PORT MACQUARIE AIRPORT CHANGES TO APPROACH PROCEDURES

Airservices is proposing to implement changes for aircraft arriving to Port Macquarie Airport from August 2019.

Figure 1: Existing and proposed flight paths for aircraft arriving to Runway 03

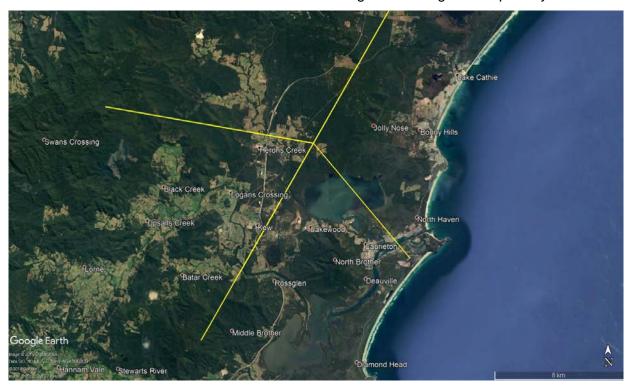
1. Lowering of the altitude for approaching aircraft to Runway 03

The minimum safe height that aircraft may fly before they begin their final descent to Runway 03 will be lowered from 4,100 feet to 2,600 feet (a reduction of 1,500 feet).

Additionally, there will be the introduction of an airspace step to enable aircraft to commence their descent to a lower altitude earlier. Currently aircraft remain at 4,100 feet before beginning their final descent to land. The new procedure will keep aircraft at 4,100 feet but then will add a lower step of 3,240 feet (a reduction of 860 feet) before aircraft begin their final descent.
